UNITED STATES  
DEPARTMENT OF THE INTERIOR  
BUREAU OF LAND MANAGEMENTFORM APPROVED  
OMB No. 1004-0137  
Expires: October 31, 2014**SUNDRY NOTICES AND REPORTS ON WELLS**  
**Do not use this form for proposals to drill or to re-enter an abandoned well. Use Form 3160-3 (APD) for such proposals.**5. Lease Serial No. **LC065421**

8. Well Name and No.  
BRADLEY-FEDERAL #29. API Well No.  
30-015-00387

Bradley Federal #2  
API 30-015-00387

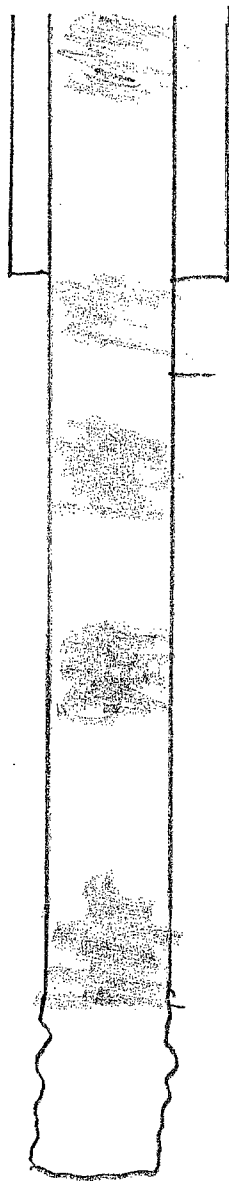
1958' - 1838' (120' plug)  
Perf 1502 from 1075' - 975'  
TO SURF. in/out of 7" CSG

~~spot 10 SK~~  
~~@ surf.~~

Perf & sq ~~45 SK @~~ 500' To Surf in/out of 7" csq.

~~spot~~ 25 SK @ 1075-975

spot 25 SK @ 1625-1525  
WOC Tag

1838-1958 (120' plug)

spot 25 SK @ ~~1908-1808~~

Bradley Federal #2  
API 30-015-00387

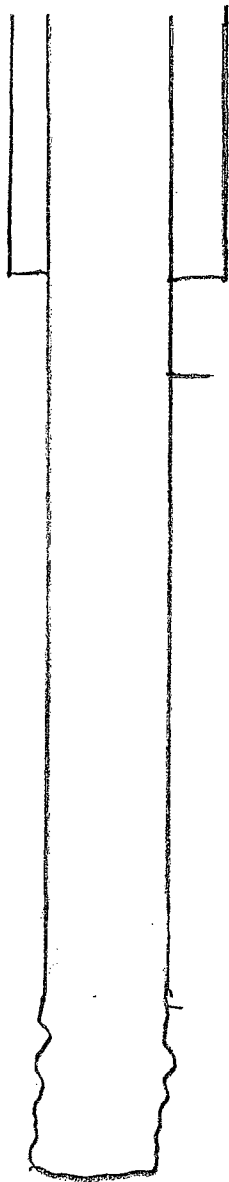
← Plug 60' - 0' Surf.  
 P<sub>1</sub> 53'

← Plug 1075' TAG  
 P<sub>2</sub> 1075'

← Plug 1625' TAG  
 P<sub>3</sub> 1625'

← Plug 1750' TAG
